North Central Texas
Council of Governments

**Recommended Regional Amendments to the
2018~~21~~ International Swimming Pool and Spa Code**
North Central Texas Council of Governments Region

The following sections, paragraphs, and sentences of the 2018~~21~~ *International Swimming Pool and Spa Code* are hereby amended as follows: Standard type is text from the ISPSC. Underlined type is text inserted. Lined through type is deleted text from ISPSC. A triple asterisk (***) identifies a new or revised amendment with the 2018~~21~~ ISPSC code.

ADD: Figure: 25 TAC §265.186 (e) (6)

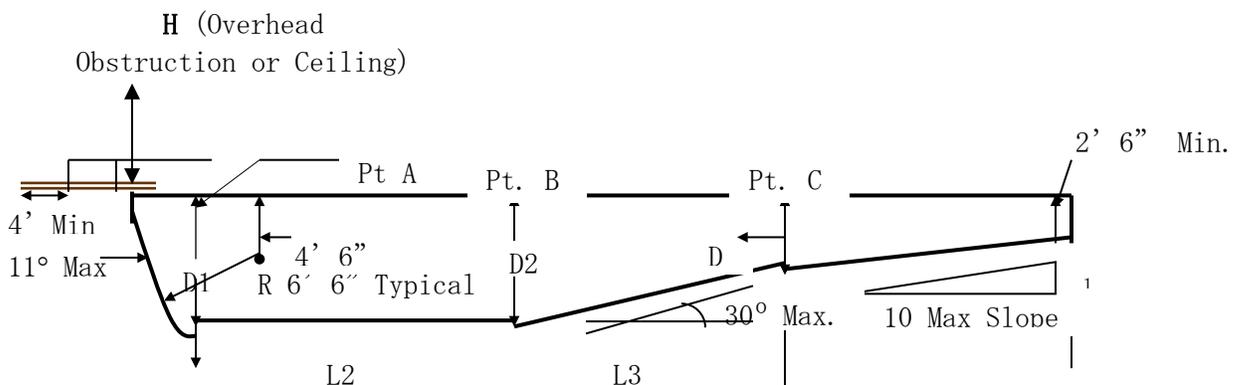
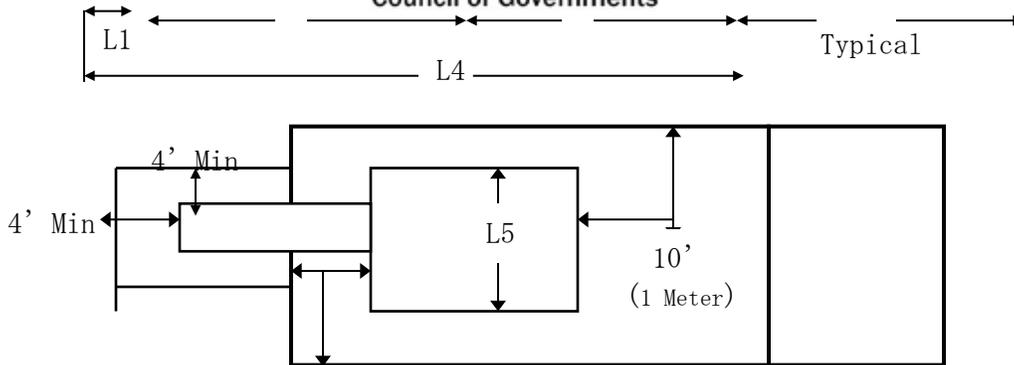
402.12 Water envelopes. The minimum diving water envelopes shall be in accordance with Table 402.12 Texas department of State Health services, Administrative Code Title 25, Chapter 265, Section 186 (e) and Figure: 25 TAC 256.186 (e) (6). (Delete Table 402.12 and Figure 402.12)

(Reason: To avoid conflict with 25 TAC Chapter 265.) *verify the table and drawings have not changed.*
